DEVELOPMENT REVIEW BOARD REPORT

MEETING DATE: April 20, 2006

CASE NUMBER/ PROJECT NAME	96-DR-2005 Wilshire Villas		
LOCATION	7979 E Wilshire Drive, at the southwest corner of E. Wilshire Drive and N. Hayden Road		
REQUEST	Request approval of a site plan and elevations for an 18-unit condominium development.		
OWNER	Wilshire Land, LLC 480-947-6200	ENGINEER	BCA Companies 480-948-9710
ARCHITECT/ DESIGNER	Bollinger & Cardenas Architects 480-315-5426	APPLICANT/ COORDINATOR	Elizabeth Ross WSL LOB, LLC 480-947-6200
BACKGROUND	<p>Zoning</p> <p>The eastern two-thirds of the site is zoned R-5C (Multi-family Residential) District, while the western one-third is zoned R-3 (General Residential) District. The dual zoning resulted from the area's history of rezoning and land assembly. Each of the zoning districts has slightly different standards pertaining to allowable density, building heights and setbacks.</p> <p>For properties located within multiple zoning districts, a property owner may either submit Rezoning and Major General Plan Amendment applications requesting a single zoning district/land use designation, or create a design that conforms to the development standards of each zoning di

SECOND FLOOR PLAN

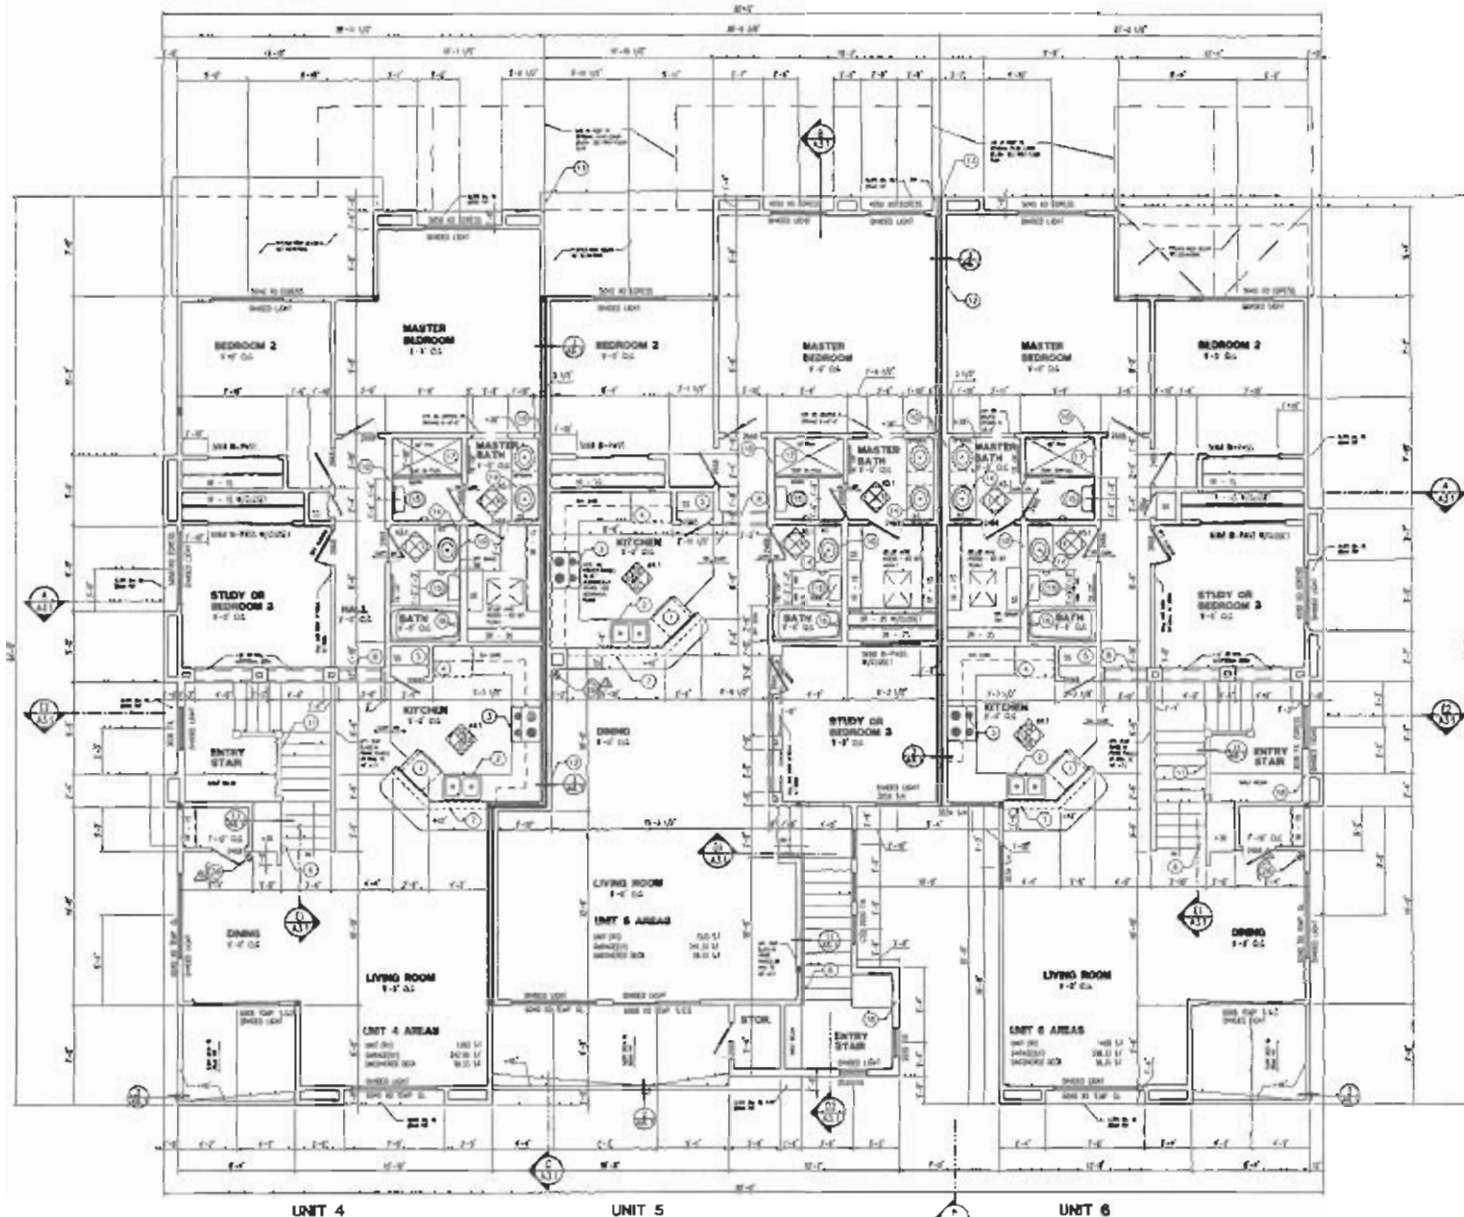
First floor units will have outdoor patios with optional patio covers, while second floor units will include balconies. Staff has identified that two of the floor plans for second floor units (Units 4 & 6) do not meet ordinance

requirements for private outdoor living space. However, staff notes that the approximate 24 square foot deficit can be remedied by a slight adjustment of interior wall locations. As such, a stipulation has been included mandating compliance with this ordinance provision.

- A. *A private outdoor living space shall be provided adjoining each dwelling unit equal to a minimum of ten (10) percent of the gross size of the dwelling unit, except that dwelling units above the first story shall provide such space equal to a minimum of five (5) percent of the gross size of the dwelling unit.*
